BEFORE THE FLORIDA PUBLIC SERVICE COMMISSION

In re: Territorial Dispute Between)
Talquin Electric Cooperative, Inc. and)
the City of Quincy)
_____))
DOCKET NO. 20250039-EU

**CITY OF QUINCY'S RESPONSES TO THE PSC's
THIRD DATA REQUEST**

SHEET NUMBER:
C-1.00

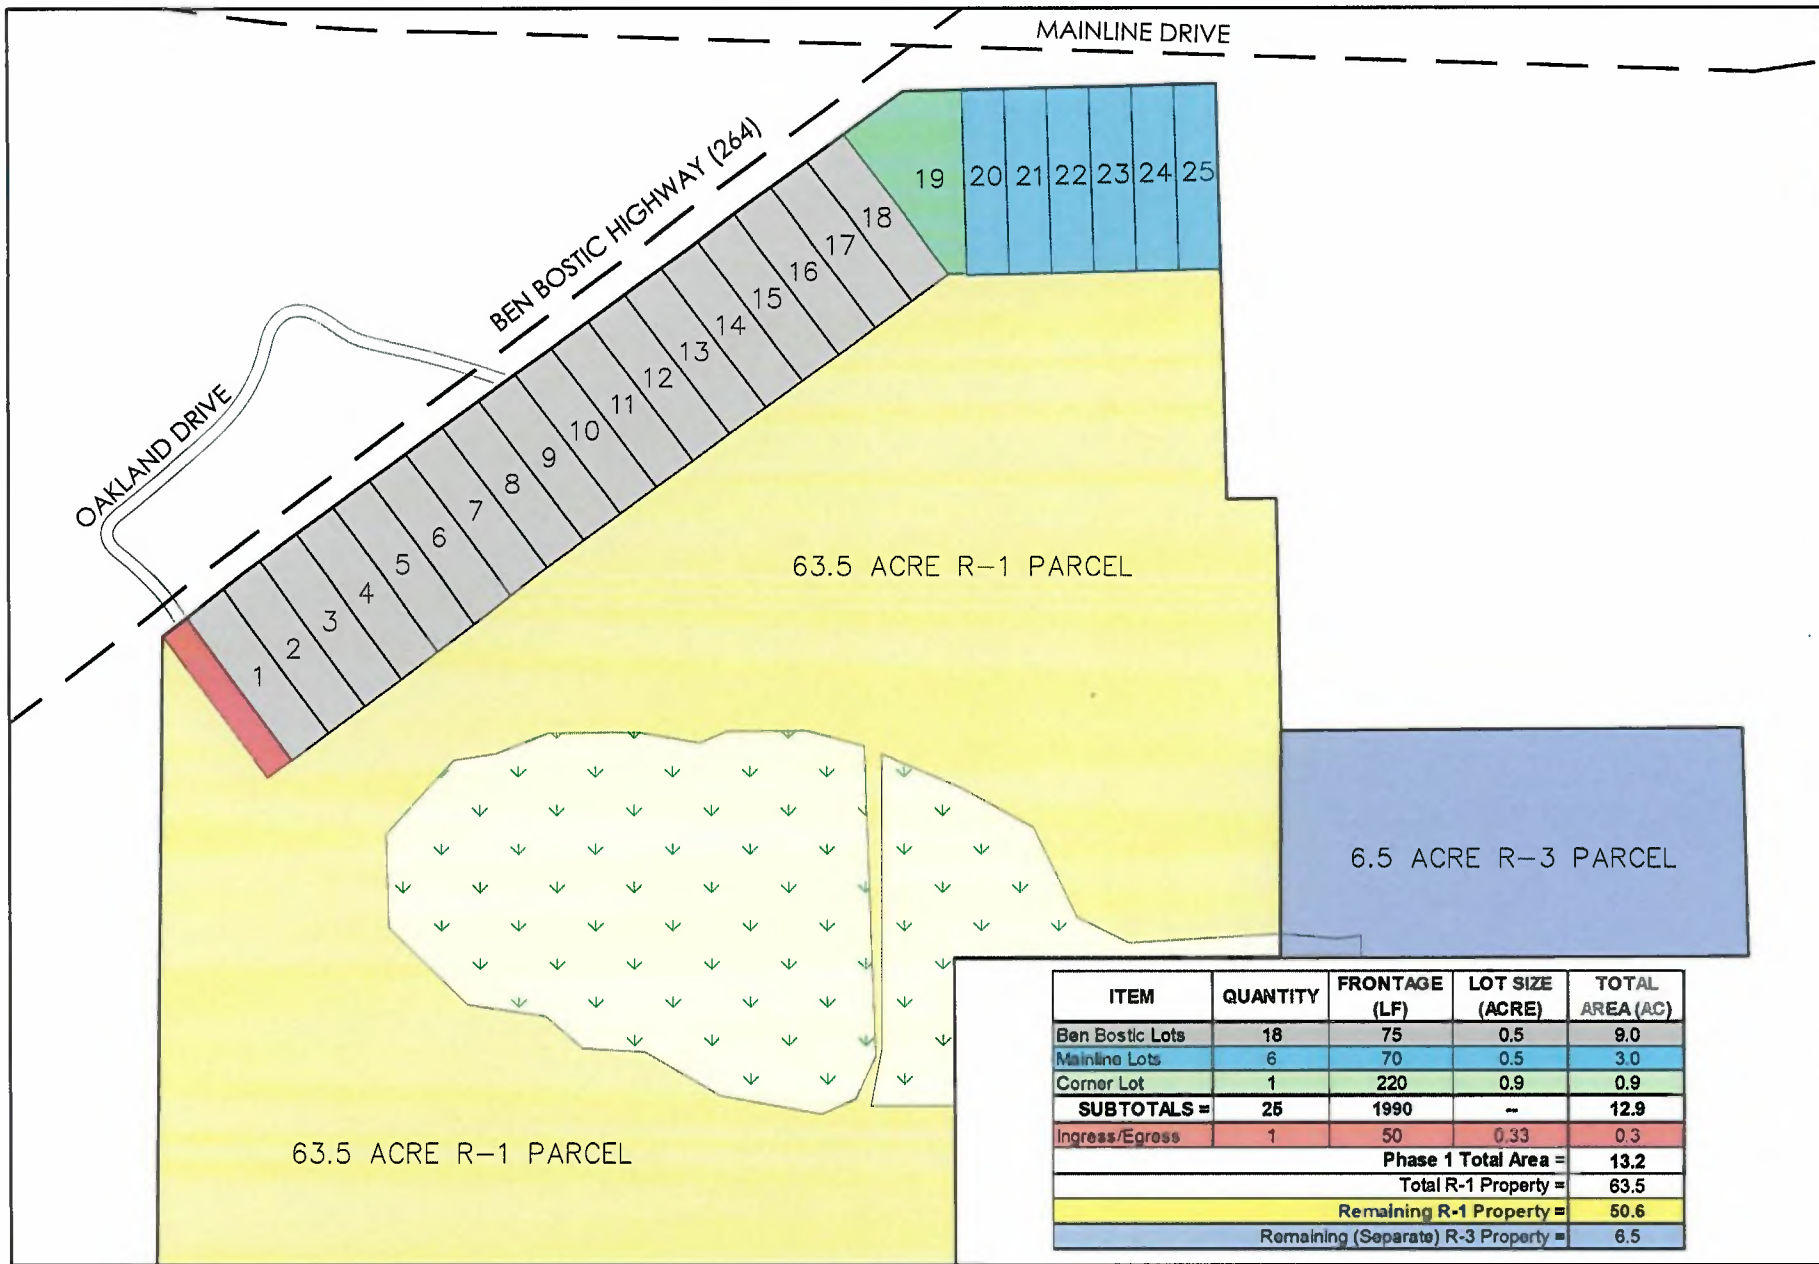
PSC TDR 5. “Overlaid on the map provided, please provide clearly defined designations (with a key) of Phase 1 through Phase 4 of the proposed development areas. If necessary, the provided map can be expanded or cropped to allow sufficient space for the requested detail.”

See Exhibit D. Page 1 depicts Phase 1 in teal and Phase 4 in bright red. Page 2 includes the area of Phases 2 and 3 in yellow. Page 3 is the Gen Land plat map, previously exhibited by Quincy’s Response to the SDR.
